## Staff Report OSLO BAY APARTMENTS SITE PLAN REVIEW and BOUNDARY LINE ADJUSTMENT

**To:** Heather Wright, Poulsbo Planning and Economic Development Director  
**From:** Karla Boughton, Special Projects Planner  
**Date:** August 12, 2022  
**Subject:** Oslo Bay Apartments | Site Plan Review | P-12-05-19-01

**Figure 1: BLA Before and After Configurations**

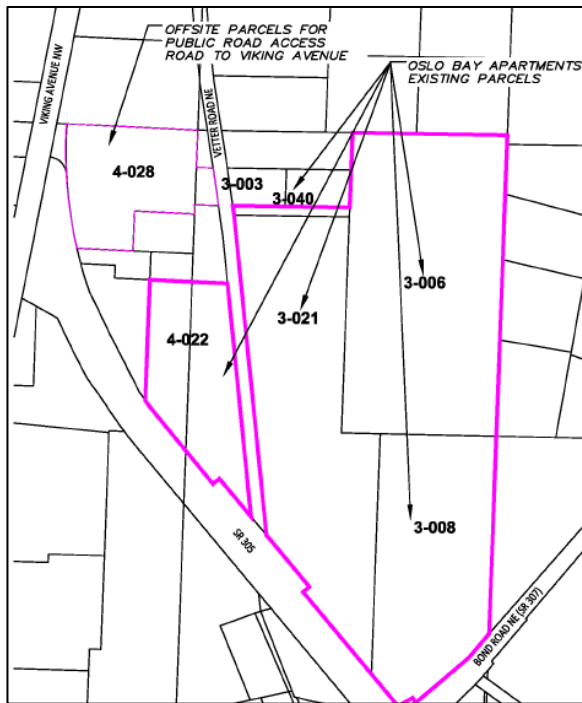
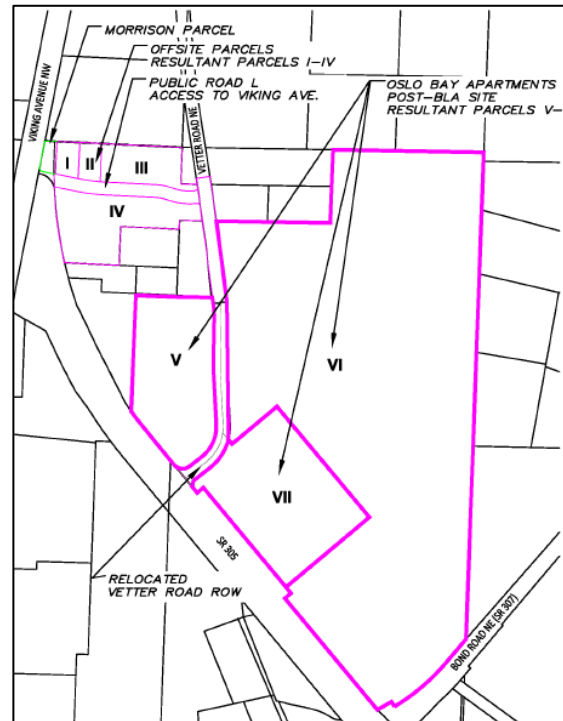
In Figure 1 below, Parcels after BLA, parcels I-IV are identified as off-site area and parcels V-VII are identified as on-site. The site and off-site parcels are noncontiguous but connected by Vetter Road ROW. Proposed improvements to the off-site parcels include only the construction of the new road L connecting Vetter Road NE to Viking Avenue NW. Improvements to the on-site parcels include the proposed apartment buildings and associated roads, utilities, parking, landscaping, and recreation amenities.

**Figure 9: Site Plan with highlights of on-site vehicle circulation and parking bays examples**

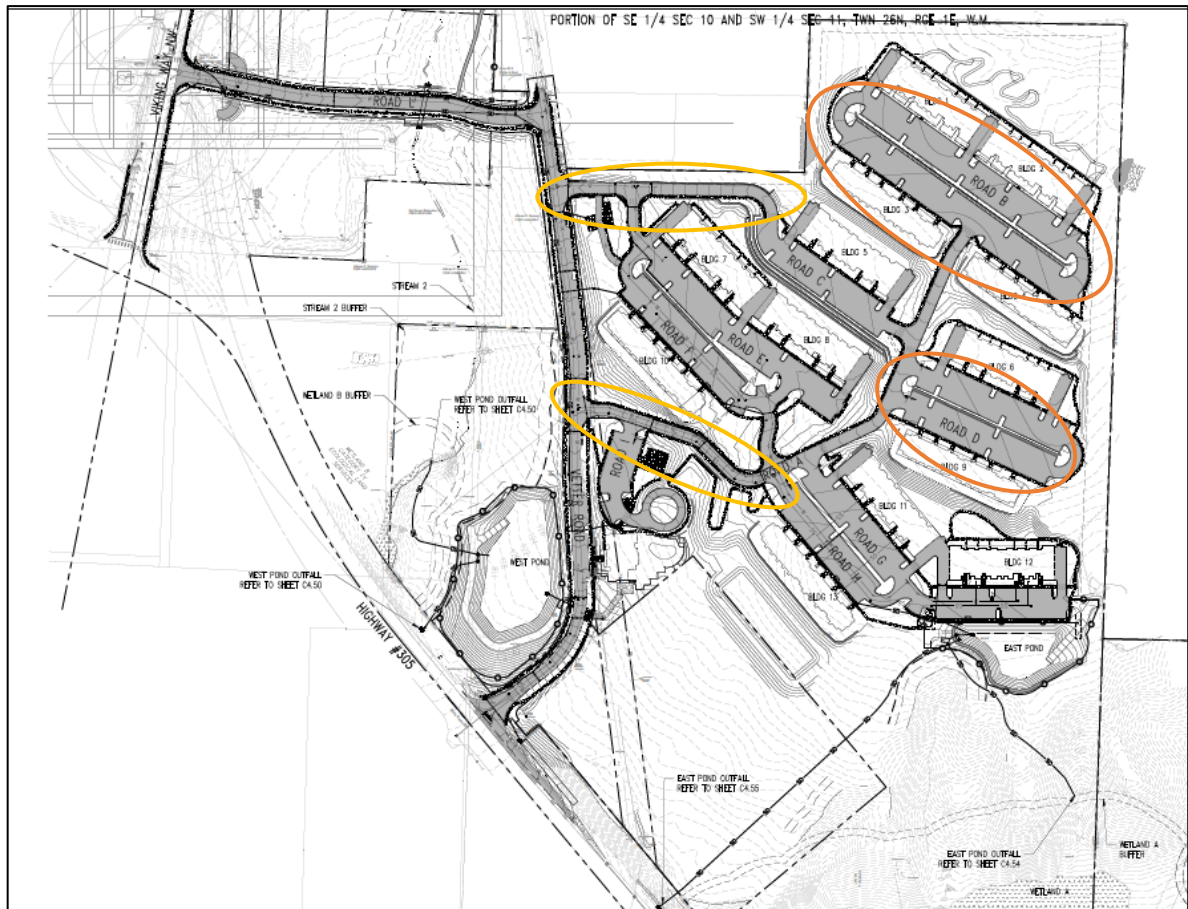
*Staff Comment:* On-site circulation is through several private streets that loop the development and circulate through a series of parking bays. The private streets must meet fire access road requirements. The private streets “Road A” and “Road C” connect to Vetter Road. The parking garages are not visible from the traveled way through the parking bays. The parking area for the Community Center is located 15' from Vetter Road NE and is screened by a landscaped buffer.

**Figure 10: Building Architectural Elevations**

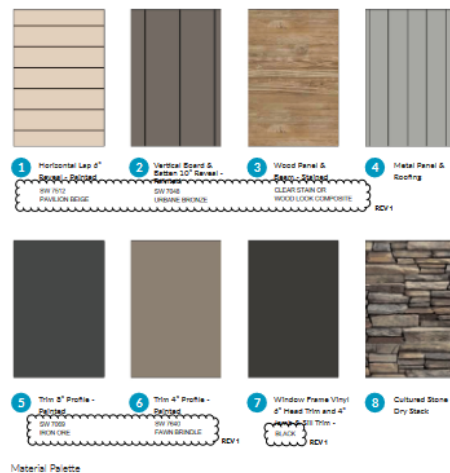
*Staff Comment:* Two building designs were created for the thirteen buildings. While the base material palettes are similar, the buildings do vary in their modulation, massing, and unit layout. Building A has prominent gable-roofed front porches that define the entry stair elements. The main façade wall reads as a single architectural expression across the entire wall. Changes in material and window groupings accent the verticality of the building. The main roof line is broken with gable roof dormers. Building B has recessed entry ways that are clearly defined by the space in between the residential units. The units on these buildings read more like townhomes or rowhouses with a defined gable shape at the top, window groupings within the walls, and exterior balconies. The ends of the buildings are grounded by stone accents and private garage doors; above the garage doors, the unit balconies and living rooms cantilever out from the wall, creating vertical and horizontal modulation. Above the garages are projecting bay windows connecting the top two floors of the unit.

**Figure 12 Before and After BLAs Configurations****Existing Parcels****Proposed Resultant Parcels with BLAs****B. PMC 17.30.040 Decision Criteria**

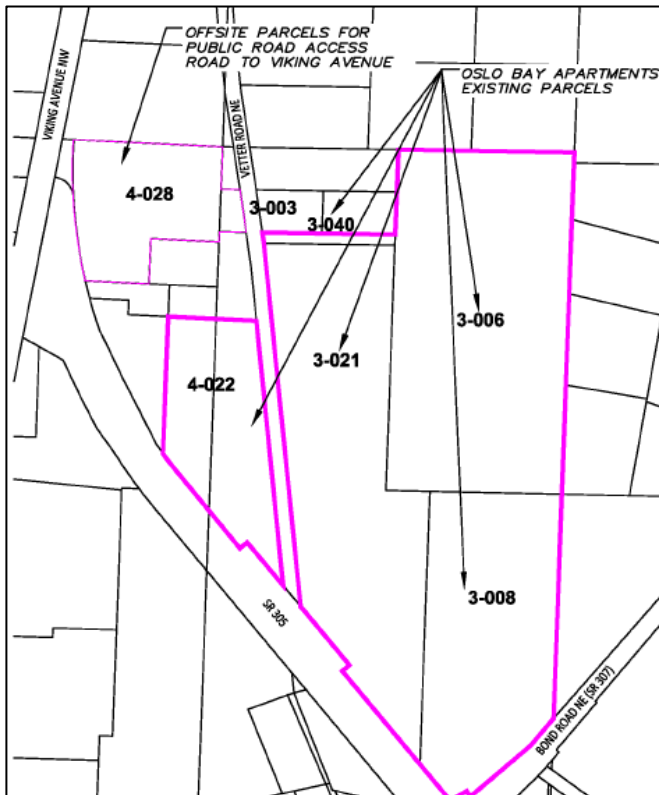
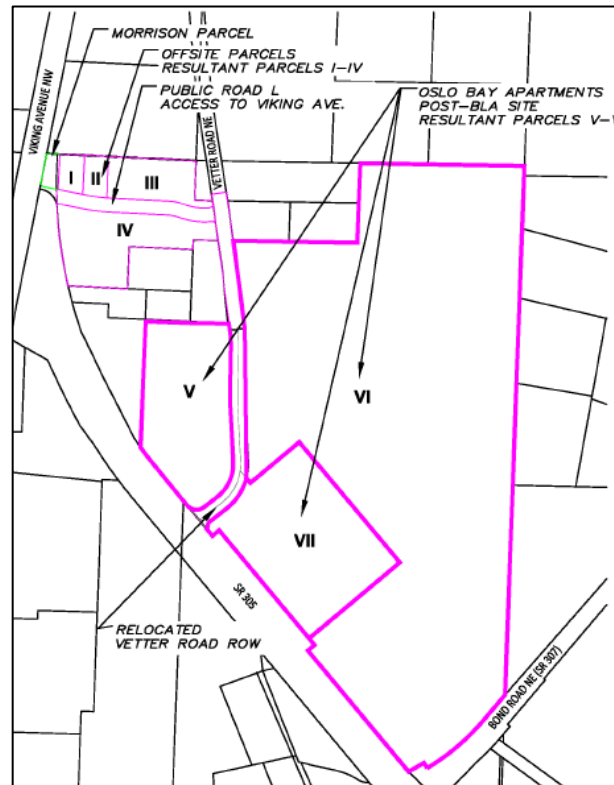
- The boundary line adjustments within the Edward Rose parcels result in Parcels I, II, III and IV and are considered off-site parcels, but is where Road L and the Western Stream are located. Parcels V and VI are the Oslo Bay Apartments parcels, and Parcel VII is considered part of the project, but will be where a future senior apartments project is to be located.
- The boundary line adjustment between Resultant Parcel I and a lot owned by James B Morrison Family LLC (tax parcel 102601-4-038-200). This BLA facilitates a public road connection of Road L to Viking Avenue NW that is coincident with the Arco/Sonic driveway.

**Figure 13: Before and After BLAs Zoning**

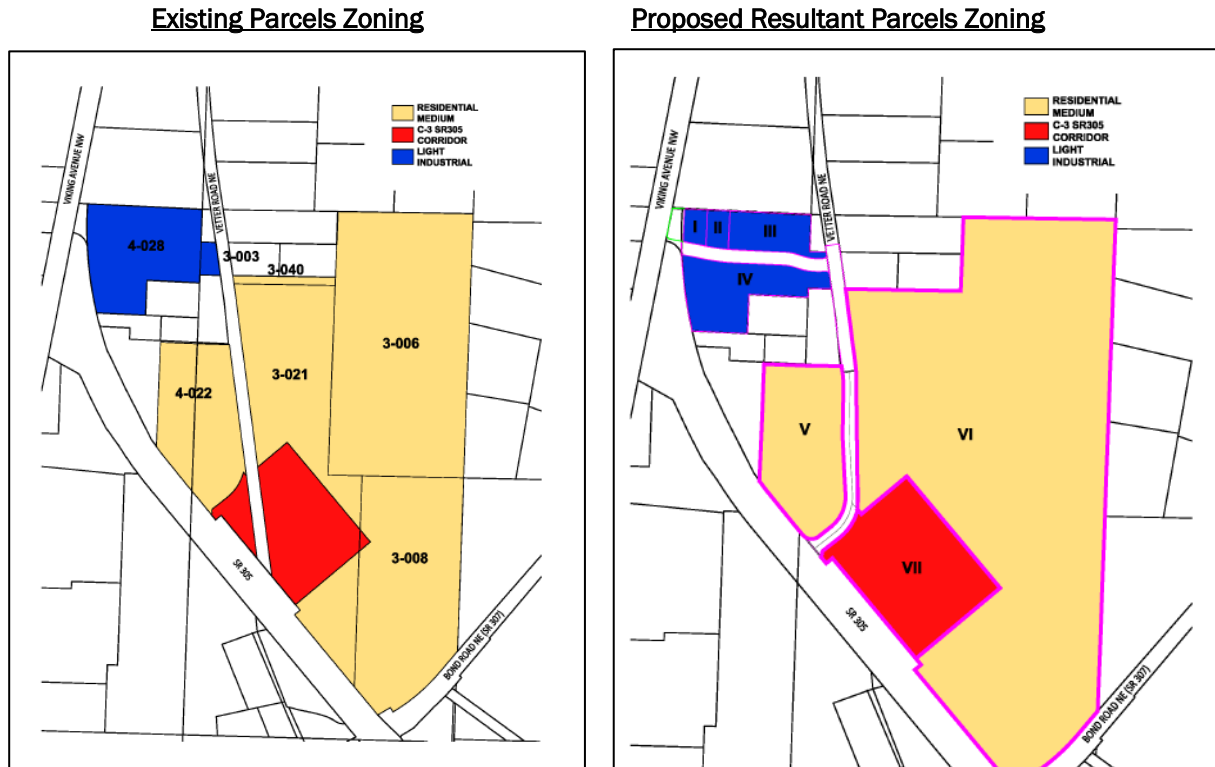
*Staff Comment:* The boundary line adjustments between the off-site parcels (I-IV) and between Parcel I and Morrison, are all zoned Light Industrial, and therefore no parcel will result in being located partially within and partially outside of any zoning.

On-site parcels V and VI are zoned Medium Density and Parcel VII is zoned commercial. The vacation and realignment of Vetter Road will modify and straighten Parcel VII's boundary but will not result in any parcel having more than one land use designation or zoning.

**Figure 15: Western Stream and Stream Type Break**

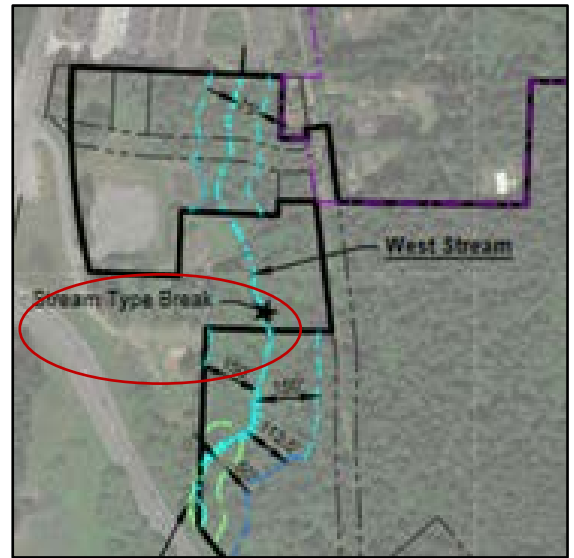
Stream typing is refined in PMC Table 16.20.315 for F streams, with F1 salmonids and F2 non-salmonids; and Ns1 and Ns2 for N type streams. It was determined in the field that the Western Stream north end is Type Ns1 and the south end is a Type F2. (See Exhibit H.1, Table 2, p. 7 and Figure 15).

**Figure 16: Road L Stream Crossing**

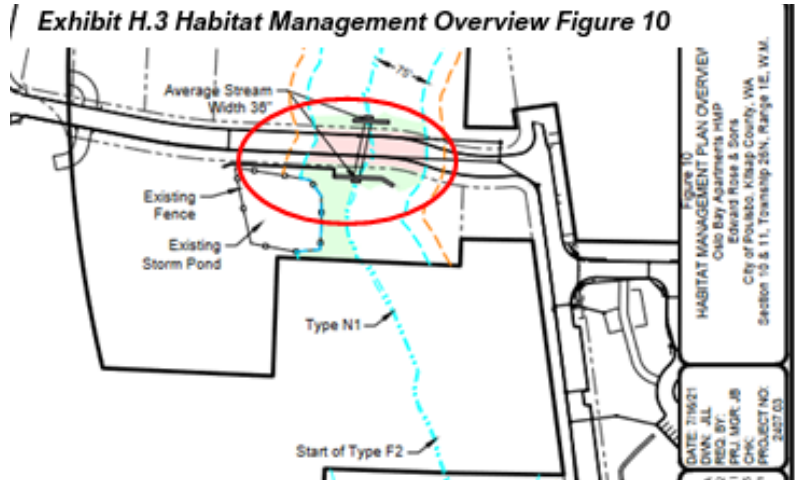
**Road L Stream Crossing and Buffer Impacts:** Road L will require a perpendicular crossing of the Western Stream Type Ns1 stream section with an 84" diameter, 94' long culvert. (See Figure 16 below.) The culvert has been sized to accommodate flows that exit the culvert emerging at the north line from the Kitsap Transit Center. The culvert will span at a narrow segment of the stream channel. Wing walls will help direct water flow into the culvert and avoid stream flows bypassing the culvert. The proposed culvert will be placed at a grade of 3.4 percent, which closely represents the current grade of the stream. Streambed gravels sized per WDFW specifications will be spread within the culvert. It is projected that approximately 55 cy of dredged material will be removed, and 55 cy of fill will be replaced as part of the Road L crossing. [Exhibit H.3 Habitat Management Plan](#) includes the "Stream Crossing Detail" as Figure 5 (pdf page 31).

**Figure 18: West Basin Stormwater Pond Stream Buffer Impacts**

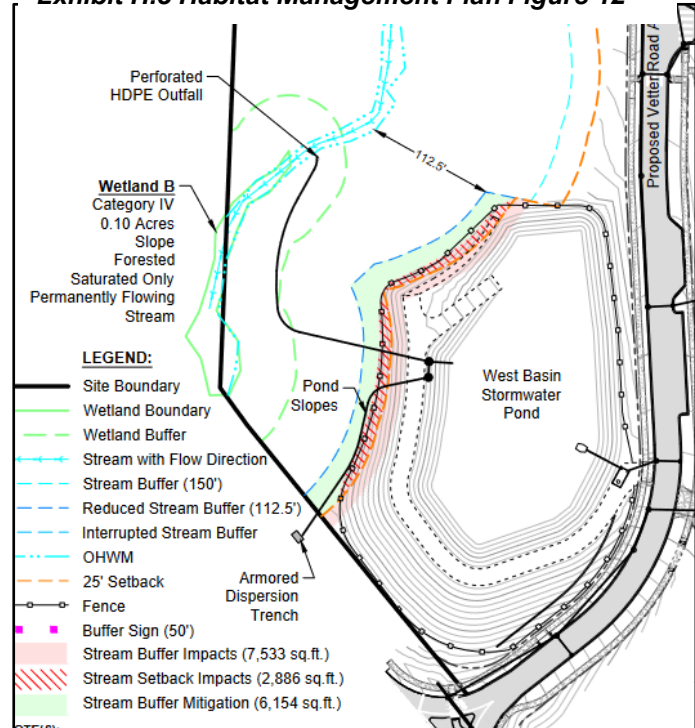
The West Basin Stormwater Pond is located to facilitate stormwater conveyance from the western portion of the project, including Road L. The required size of the pond is constrained by the Vetter Road alignment and impacts the Western Stream 150' buffer and 25' buffer setback. The applicant proposes to utilize the buffer reduction provision found in PMC 16.20.315.B.1 which allows reduction of up to 25% of the buffer width with submittal of a habitat management plan, which would result in a final buffer width of 112.5'.

In addition, the West Basin Stormwater Pond extends for approximately 2,886 square feet into the 25' buffer setback (from the 112.5' reduced buffer). The stormwater pond's fence will be along the edge of the setback. Minor encroachments into the buffer setback are allowed per PMC 16.20.315.A(5)(b) upon submittal of a habitat management plan. See Figure 18 - Exhibit H.3 Habitat Management Plan Figure 12 below. Red highlighted along western edged of stormwater pond is stream buffer impacts (7,533 square feet), red hatched area is stream setback impacts from reduced 112.5' buffer width (2,886 square feet), and green highlight is proposed stream buffer mitigation of 6,154 square feet.

*Staff Comment:* There are no direct impacts to Dogfish Creek. There are two impacts proposed to the Western Stream: 1) Road L will make a stream crossing at the northern portion of the stream; and 2) stream buffer reduction is proposed for the area adjacent to the West Basin Stormwater Pond to 112.5' and minor encroachment into the 25' buffer setback area. A Habitat Management Plan (Exhibit H.3) has been prepared to justify and mitigate these impacts to the Western Stream buffer.

Figure 20: FEMA Flood Insurance Rate Map depicting Flood Hazard Area

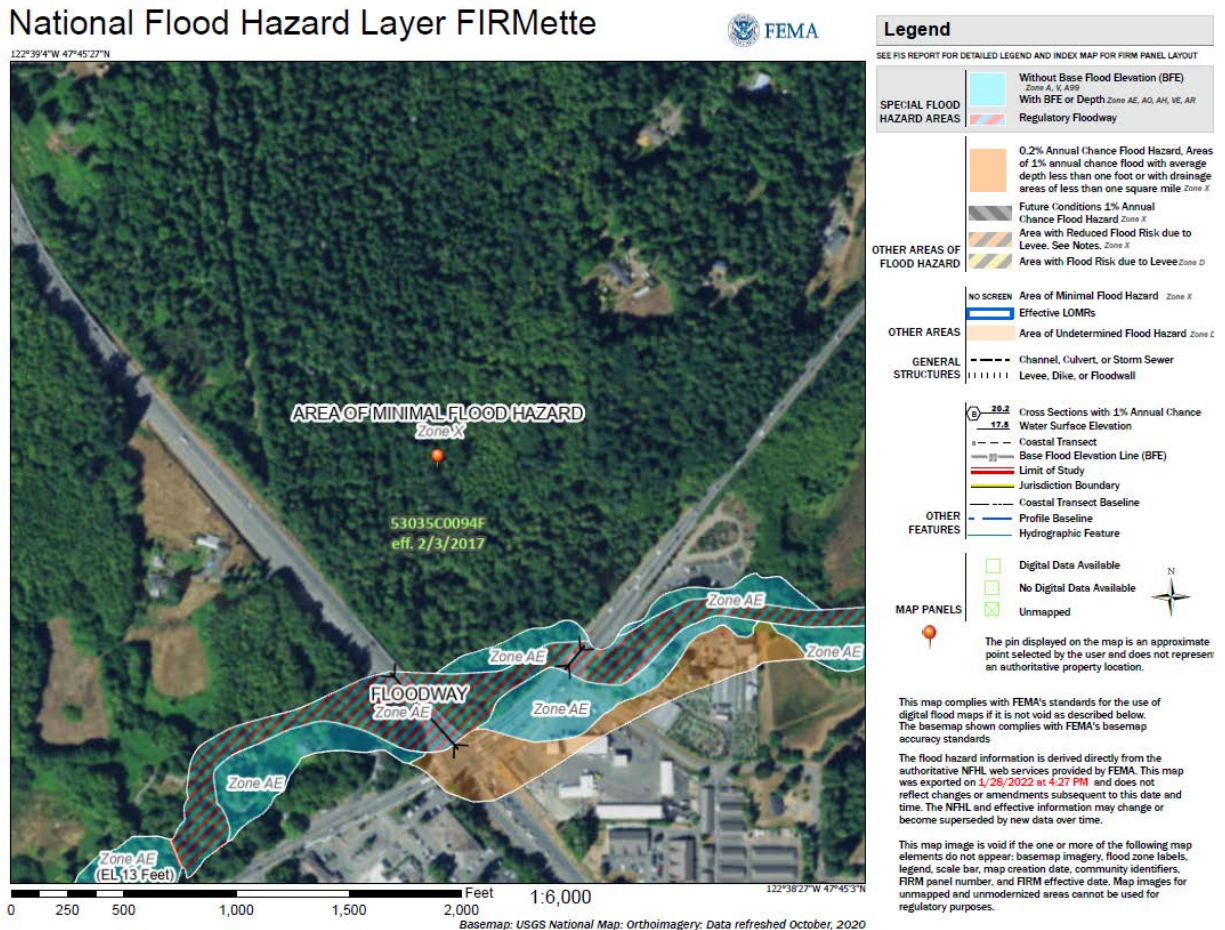
A 100-year FEMA Flood Hazard Area bisects the southern portion of the project site, along Dogfish Creek, near the parcel boundary. See Figure 20 below:

**Staff Comment:** No impacts are identified to the 100-year Floodplain zone as site development is over 600' from the flood zone and Dogfish Creek.
